**City of Springfield
Development and Public Works Department**

July 18, 2016

**Addendum Number 1 to the Contract Documents for the
Invitation to Bid for P21106; Over/Under CMP Pipe Replacement**

CLEANOUT DETAIL

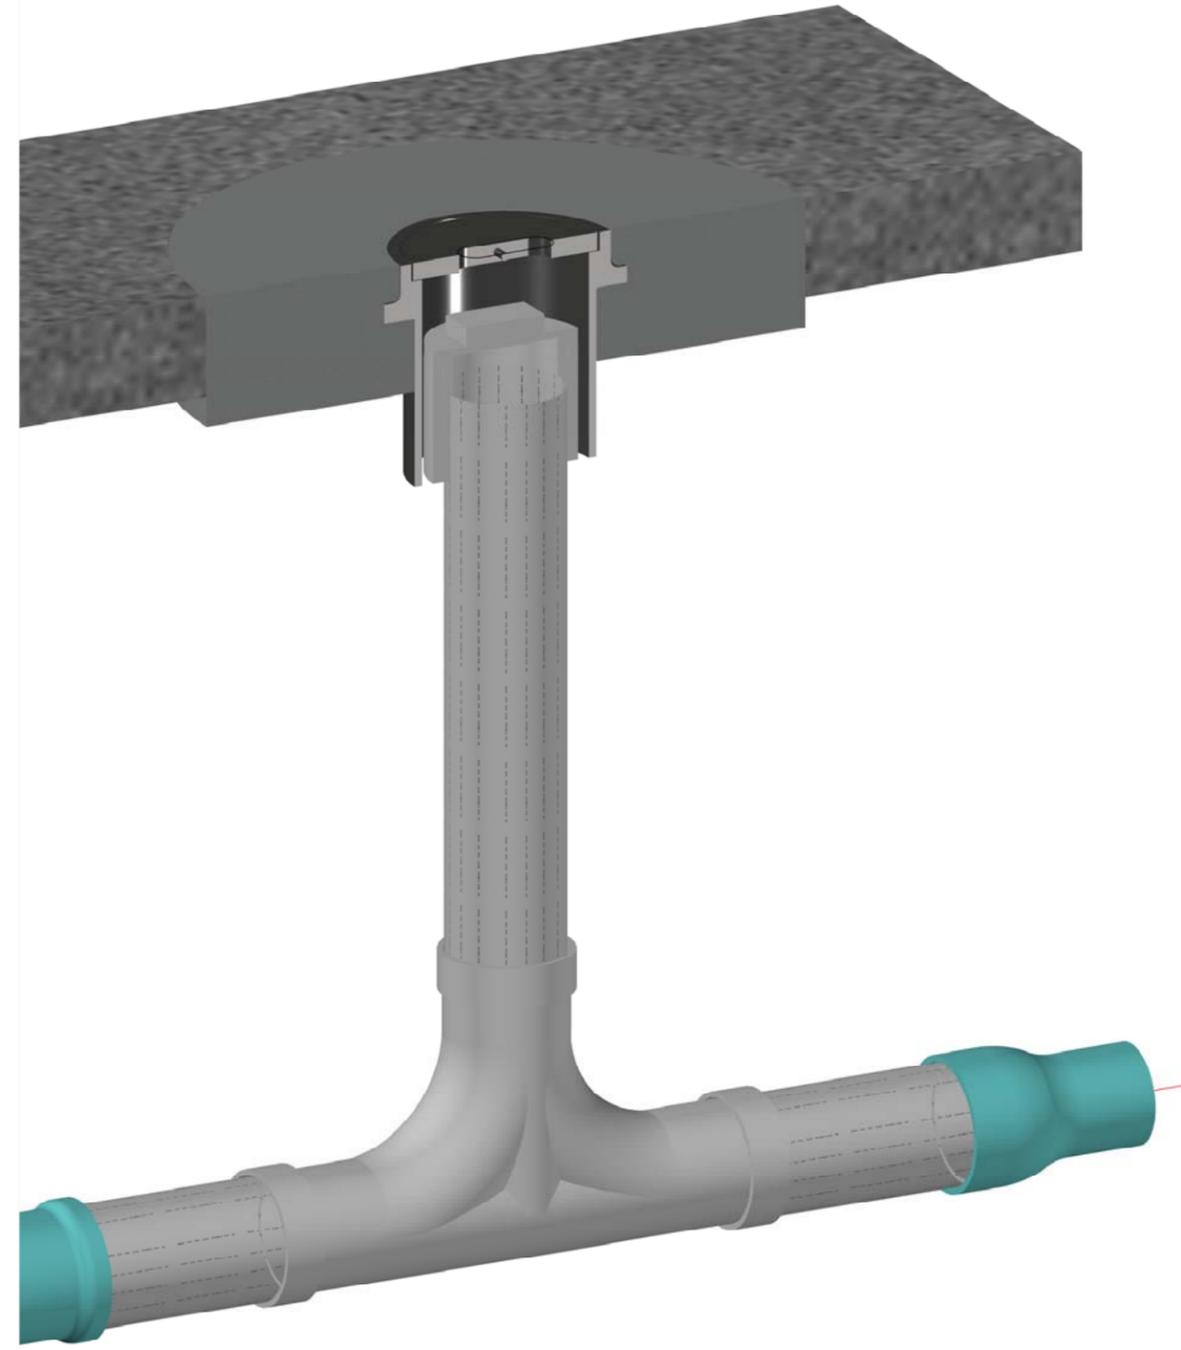
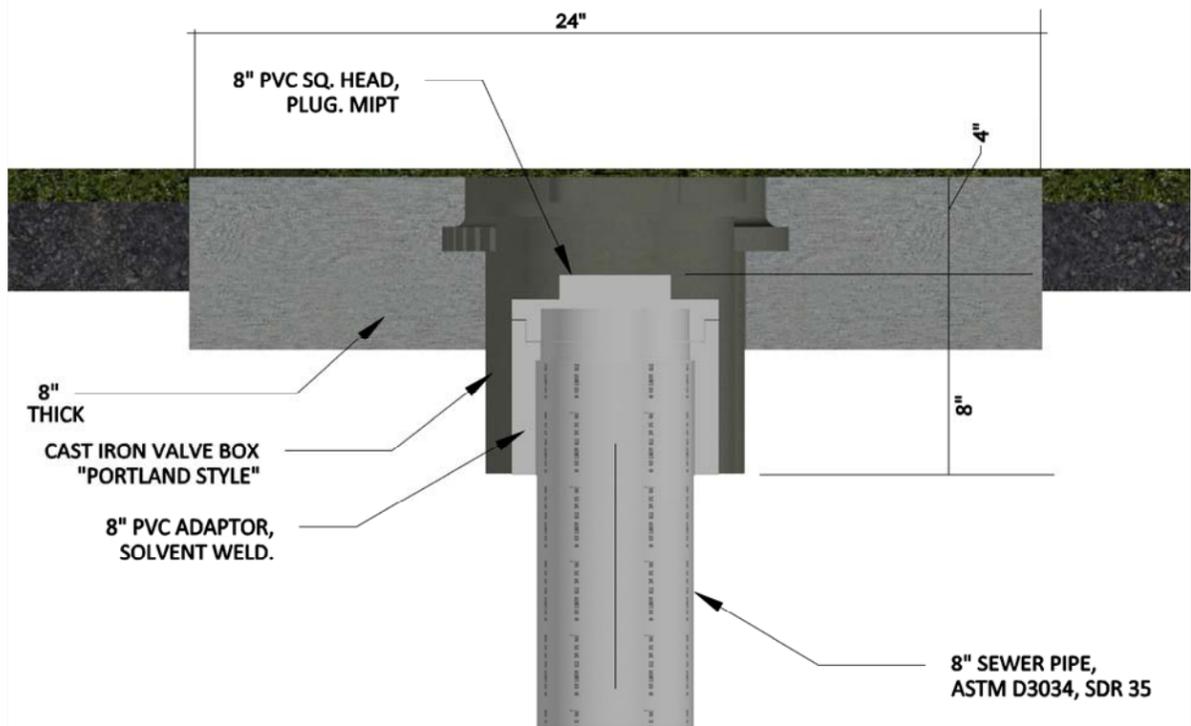
- 6.) Drawing Sheet D-7 - Delete Drawing D-7 in its entirety.
- 7.) Drawing Sheet D-8 - Drawing D-8 is being replaced in its entirety with a revised version dated 07/18/16. See Attachment 2 to this Addendum.

Bid Item 15 calls for providing and connecting an 8-inch cleanout and cap as shown in the detail on Sheet D-8, for placement at the west end of the 8-inch service for the new school as shown on Sheet P-9.

Attachment 3 to Addendum 1 Dated 07/18/16

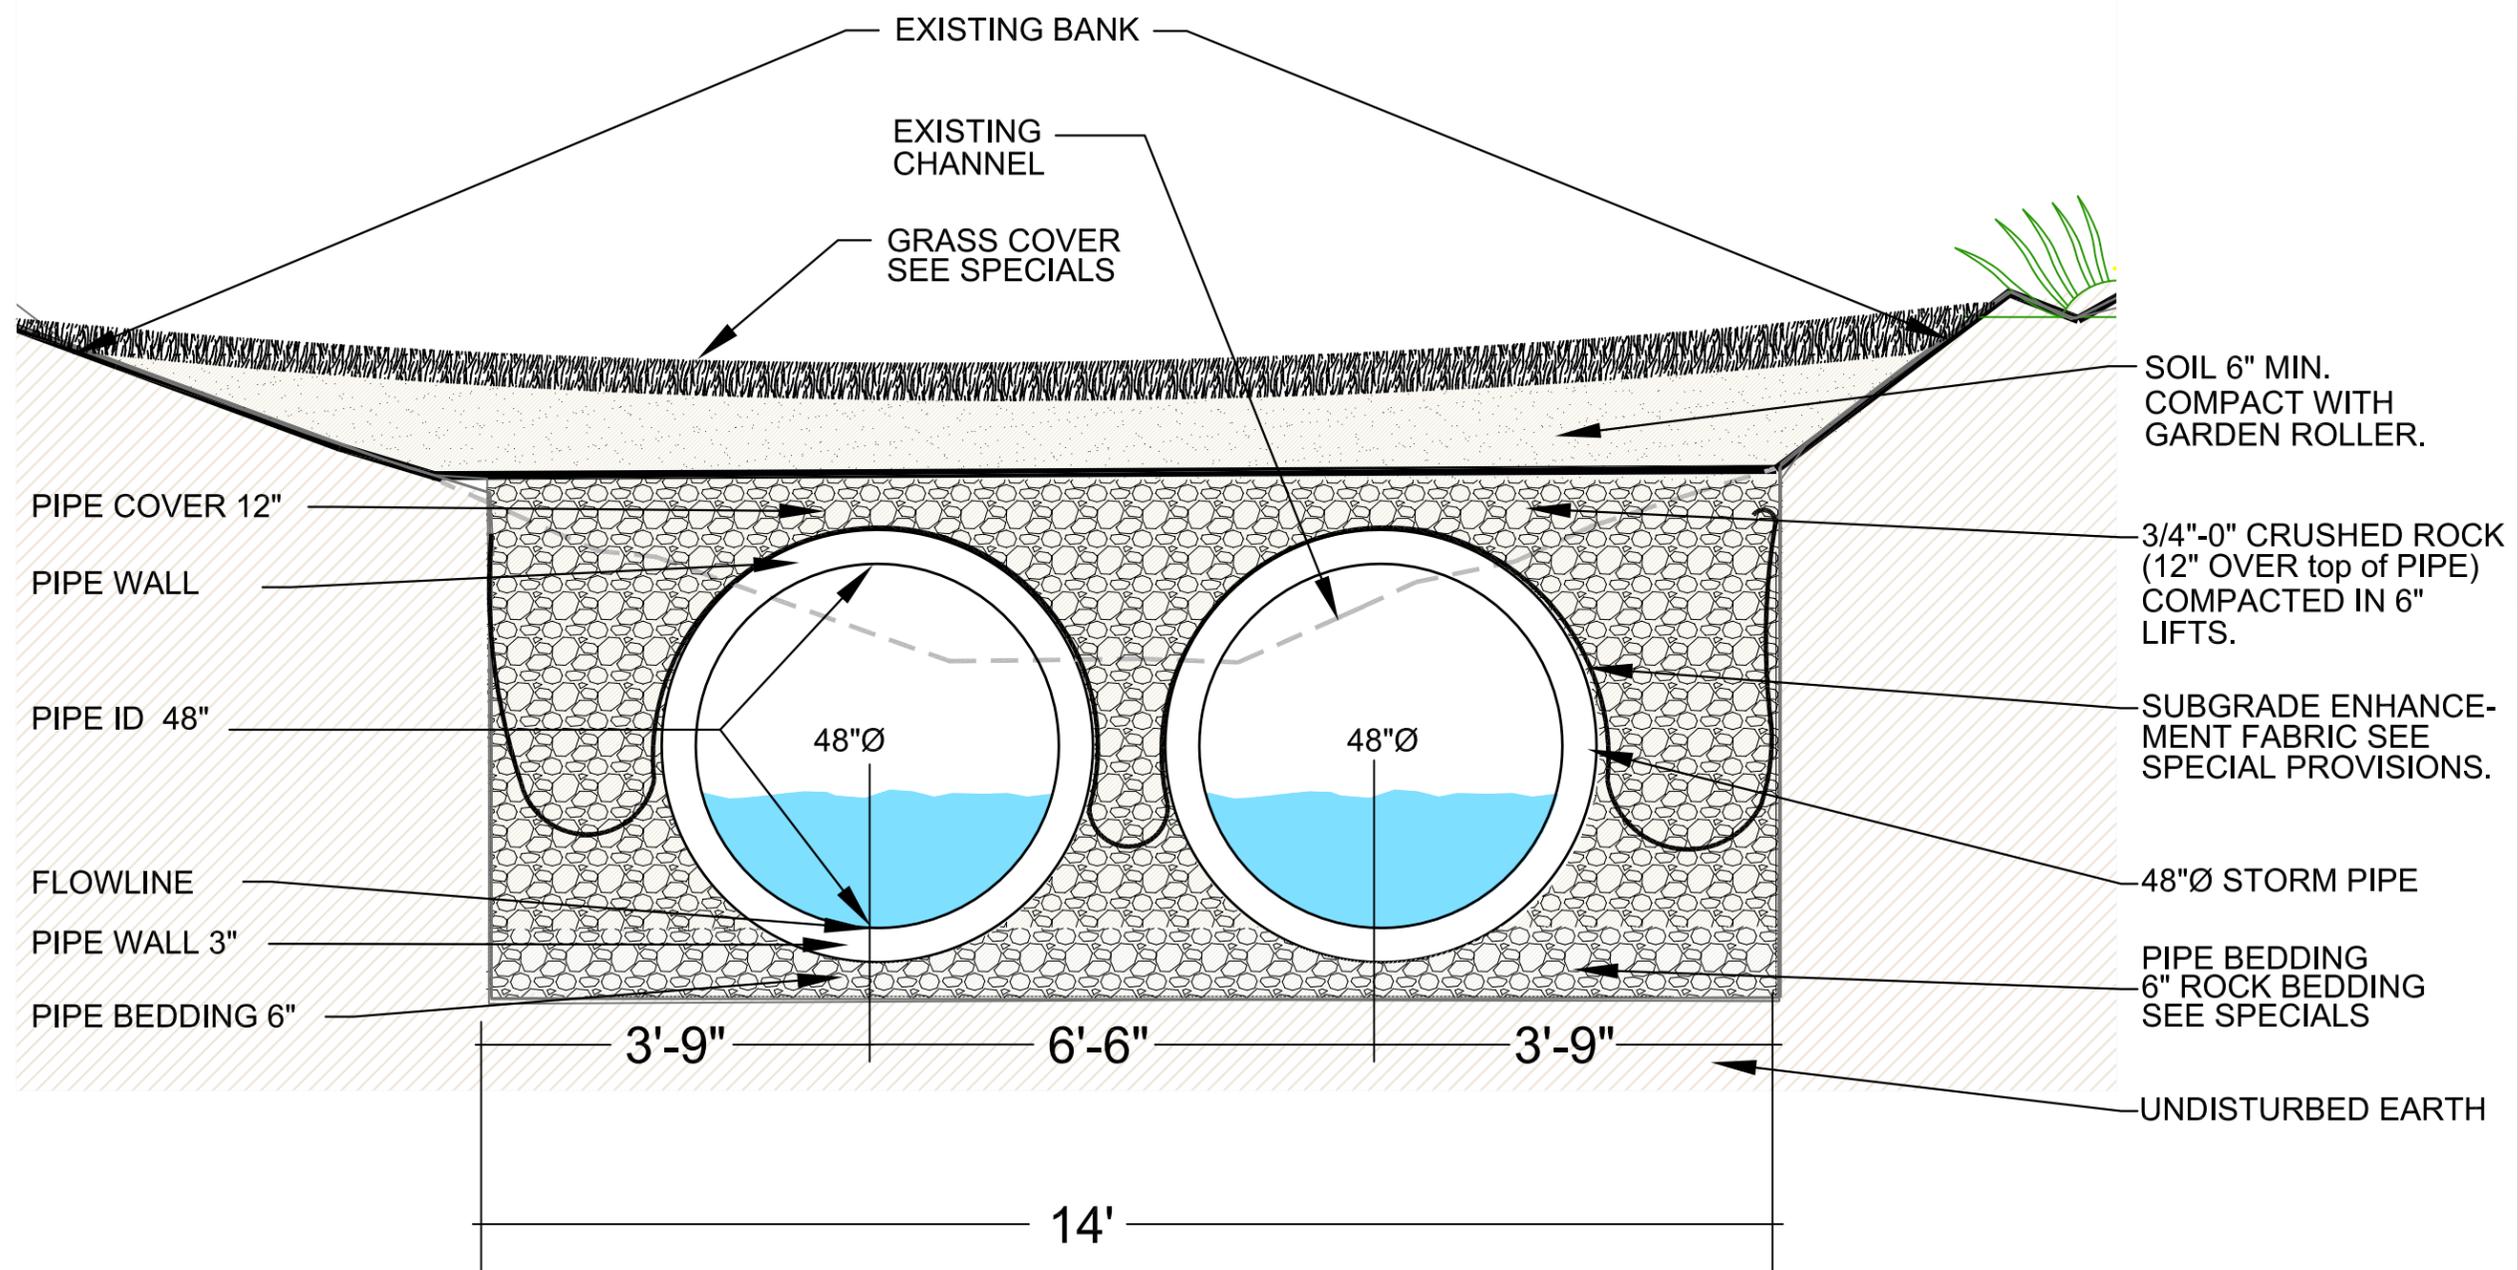
- 8.) Drawing Sheet P-11 - Drawing P-11 is being replaced in its entirety with a revised version dated 07/18/16. See Attachment 3 to this Addendum.
- 9.) Drawing Sheets V-1, V-3, V-6 and V-8 - Delete the following Note: All Steel = 40 KSI Deformed. Replace it with the following: All Steel = 60 KSI Deformed.
